INITIAL FIRE SAFETY INSPECTION REPORT

Fuli Industrial Ltd.

RSC ID: 25846

PLOT NO. 148-151, DEPZ (OLD ZONE), GANAKBARI, ASHULIA, SAVAR, DHAKA

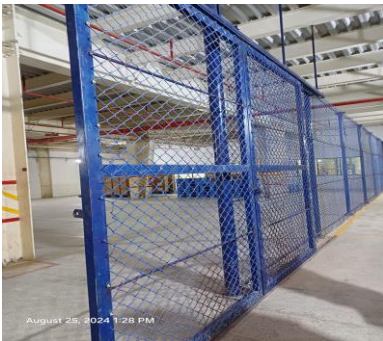
F-7	Fire Rated Construction	Elevator shaft are directly open into production floor without proper fire separation (Doors are not fire rated). Location: Building-1.	Ensure minimum 1.5-hr fire rating for the doors of elevator shafts otherwise close the shafts area with 2-hr fire rated construction barrier and 1.5-hr fire rated doors. So, rearrange the facility to provide separate enclosure for lifts. If not possible anyway provide a minimum 2-hr fire- rated elevator shaft with listed fire rated lift landing door to separate from each floor level. Factory shall ensure that, all the design, datasheet, certificate, and proposed drawing of installation has been reviewed from the RSC prior to install the passive fire protection system (If required).	Within 6 Months

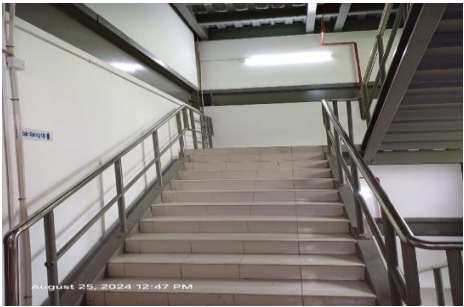
F-9	Fire Rated Construction	Exit discharge of Warehouse on ground floor has not been separated from Loading-Unloading area due to opening and damaged fire rated door (hardware, frame). Location: Building-1.	Separate the storage room by a minimum 1- hr fire-rated construction. Seal and/or protected all openings to maintain the required fire separations. Factory shall ensure that the maintenance work shall be done for the door hardware and accessories on a regular basis as per NFPA 80 and manufacturer's published guideline. Repair/ replace the hardware and accessories which are not functional or under unauthorized maintenance.	Within 3 Months
